Project Name: Boxted Solar Farm

Report Name: Response to LLFA Holding Objection

Project Number: P21-2950

This document provides a response to the holding objection received from Suffolk County Council as Lead Local Flood Authority to the proposed Boxted Solar Farm (application no: DC/23/O5127-FUL). The holding objection was received on the 15th November 2023 from Jason Skilton (Flood and Water Engineer). The LLFA's comments are enclosed at the end of this document. The comments detail that "the applicant needs to make a minor amendment to the surface water drainage strategy" and request that the submitted Flood Risk Assessment and surface water drainage strategy are re-submitted "referencing the LLFA Standing Advice – Solar Panels (PV) and Solar Farms (January 2022)". This standing advice document is enclosed at the end of this document.

Landscape Masterplan

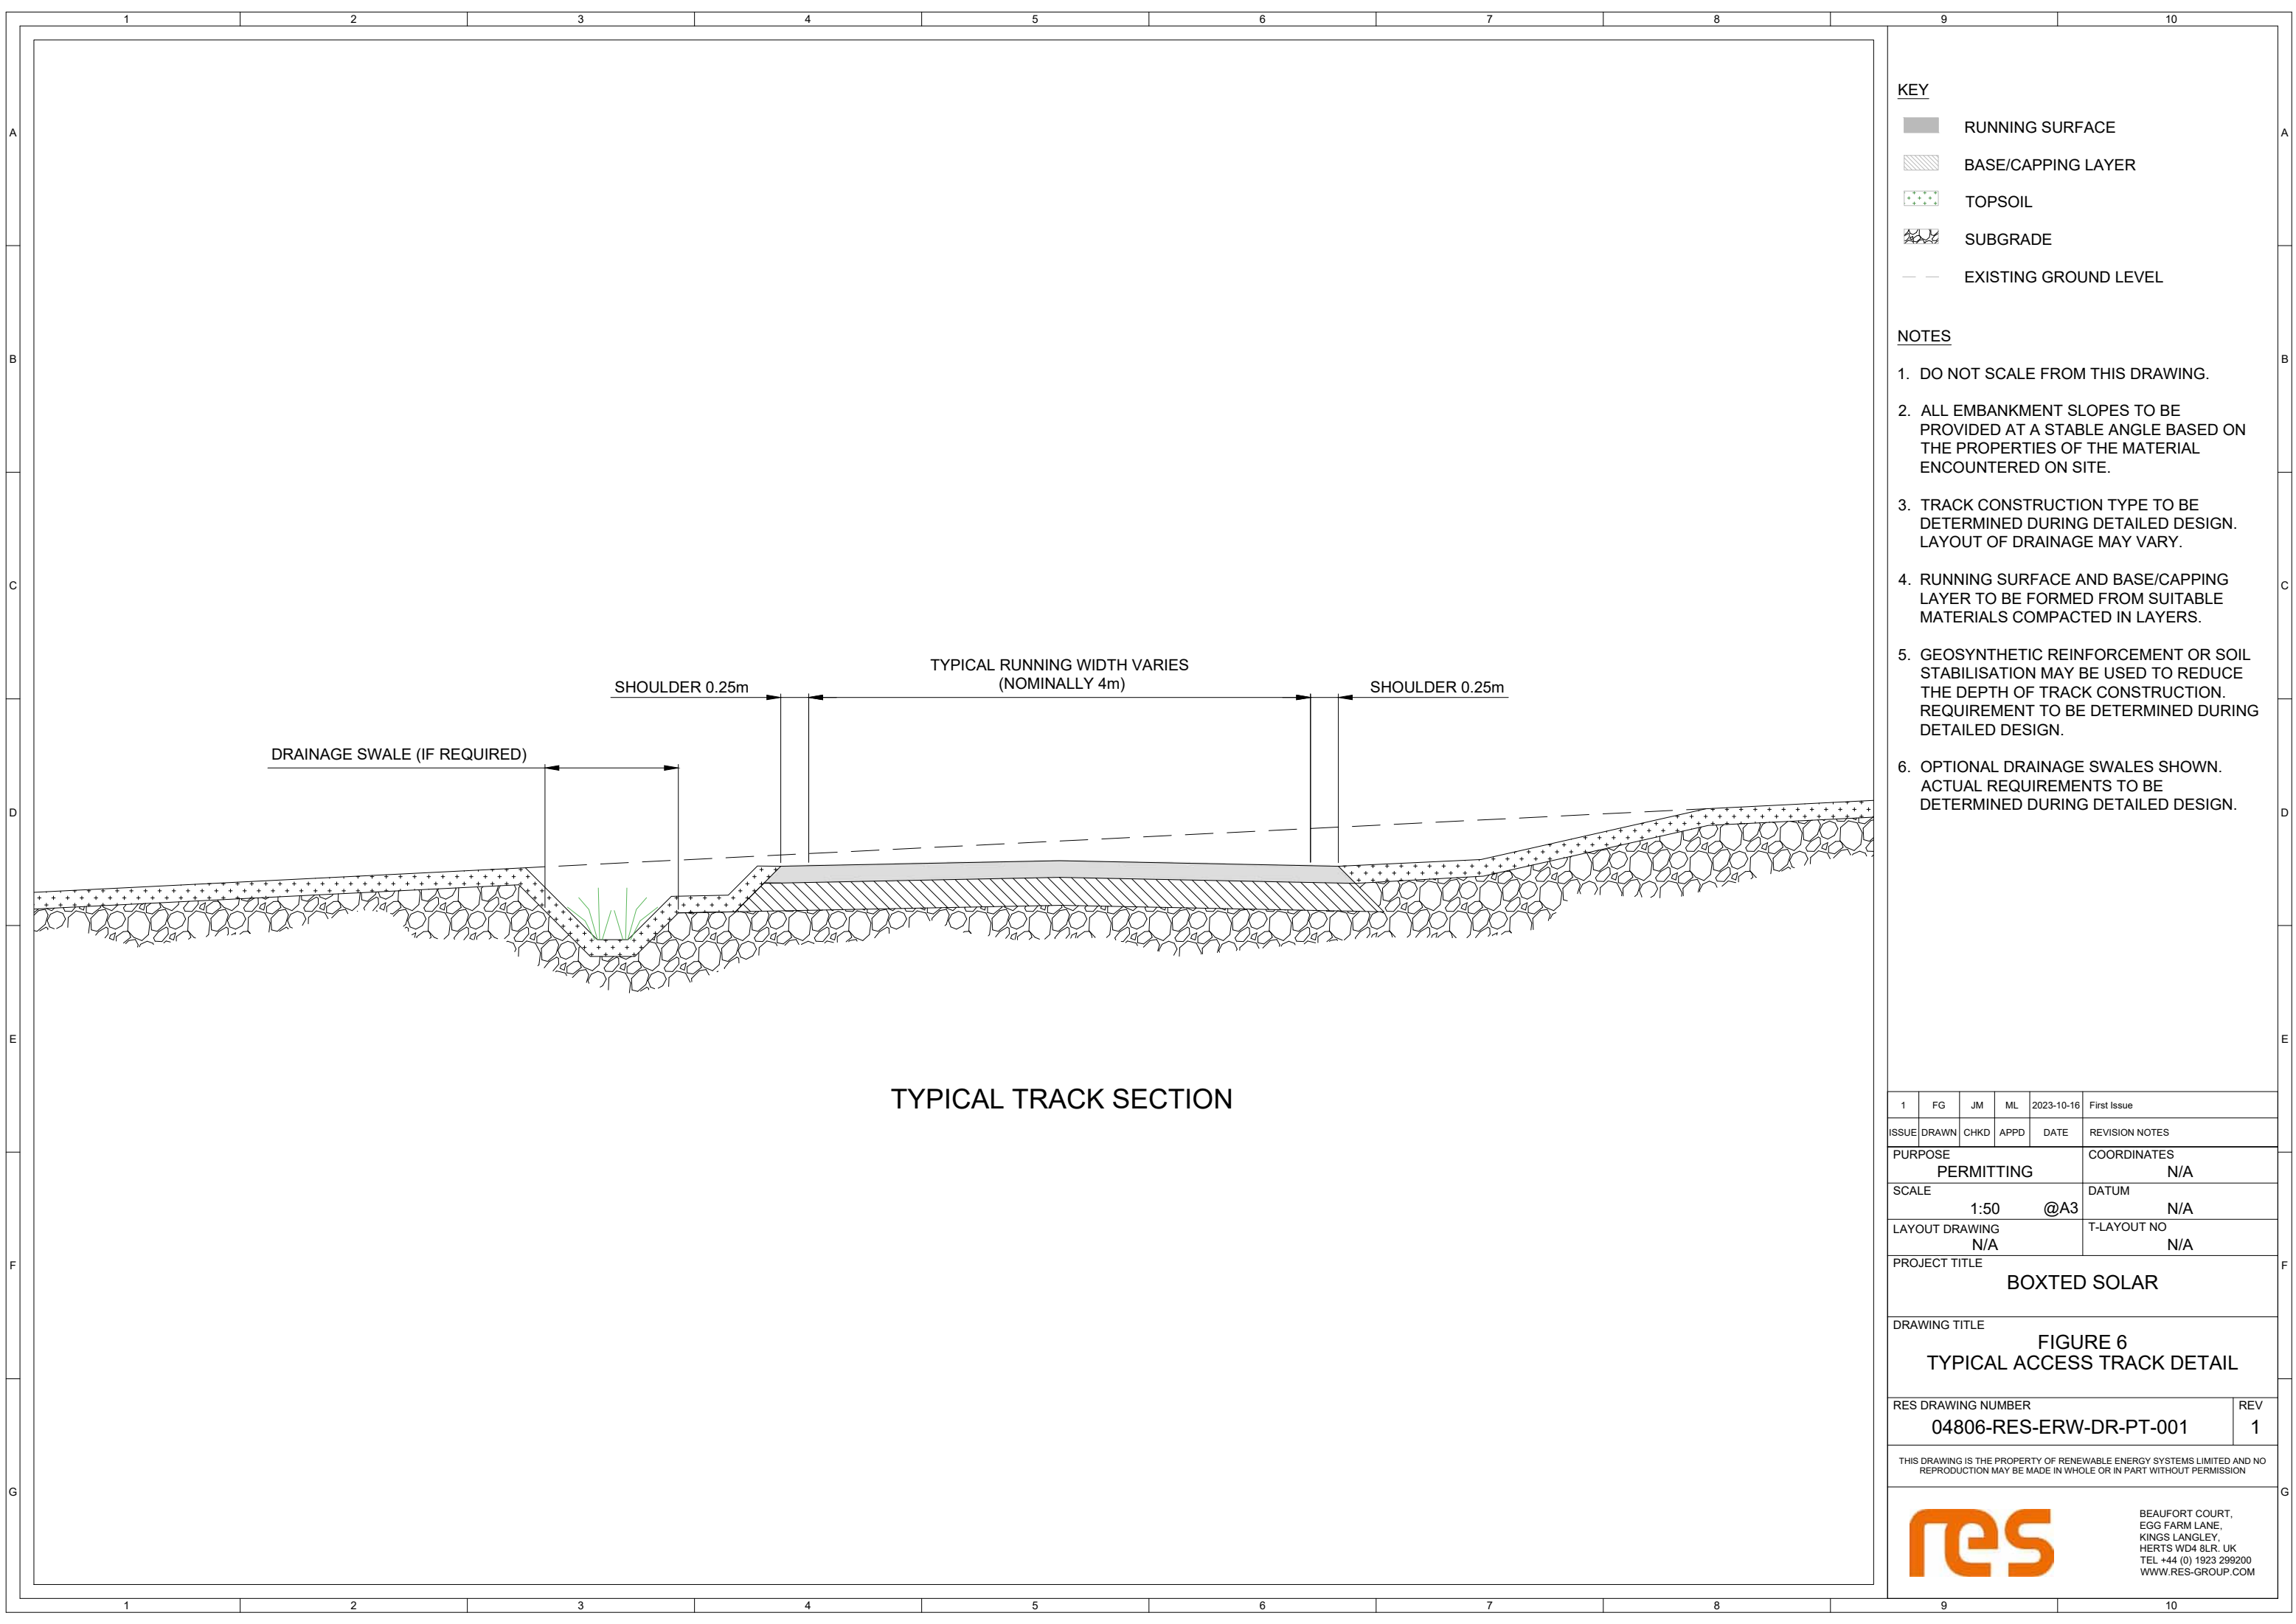
The risk of erosion between rows of solar panels was raised as a concern by the LLFA during the meeting in February 2024. The LLFA's standing advice (enclosed) does not specifically highlight the risk of erosion between solar panels but details that "the density, height and number of PV panels will dictate the type of surface water management system that is required by the LLFA. This can be done by using perimeter swales or filter strips every 5th row of PV panels".

It is confirmed that the grazing regime on site will remain low. The applicant will provide a detailed grazing regime for the site at a later date, and it is requested that the provision of this regime is conditioned. With a low density grazing regime on site, it is not considered necessary to provide filter strips on site to manage the risk of erosion between rows of solar panels. The implementation of a low grazing density regime on site will ensure sufficient vegetation cover is maintained on site. The proposed Landscape Masterplan for the site is enclosed. Land beneath the solar panels proposed on site will be maintained as grass/wildflower seed mix and not be left as bare ground which could be eroded. Cook and McCuen's

2013 report on the “Hydrologic Response of Solar Farms” states that “with well-maintained grass underneath the panels, the solar panels themselves do not have much effect on total volumes of the runoff”. It is therefore considered that the proposed landscaping on site will offer sufficient mitigation measures against the potential for erosion between rows of solar panels.
